From: bbwg-request@npogroups.org [mailto:bbwg-request@npogroups.org] **On Behalf Of** David Chambers
Sent: Friday, March 18, 2011 2:08 PM
To: BBWG Working Group
Subject: [bbwg] Wardrop Preliminary Assessment Technical Report

I have reviewed the recently released [Preliminary Assessment of the Pebble Project, Southwest Alaska](#), Wardrop-Northern Dynasty Mines, February 17, 2011.

Figure 1.7.2 Cross Section Showing Open Pit Phase Sequence

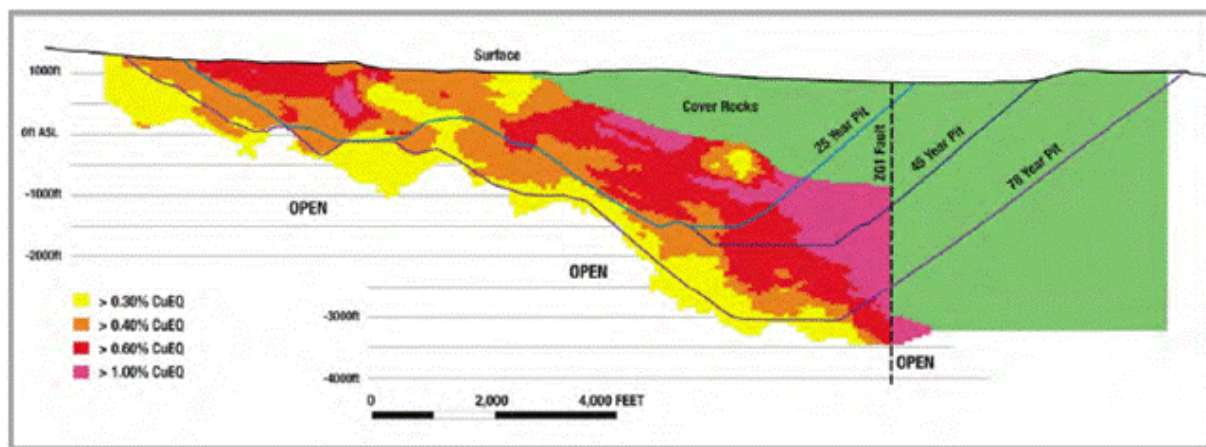
From Figure 1.7.2, I get the following dimensions:

- 25-year Pit: \approx 12,000 feet-length x 2,500 feet-depth
- 45-year Pit: \approx 14,000 feet-length x 2,800 feet-depth
- 78-year Pit: \approx 17,000 feet-length x 4,000 feet-depth
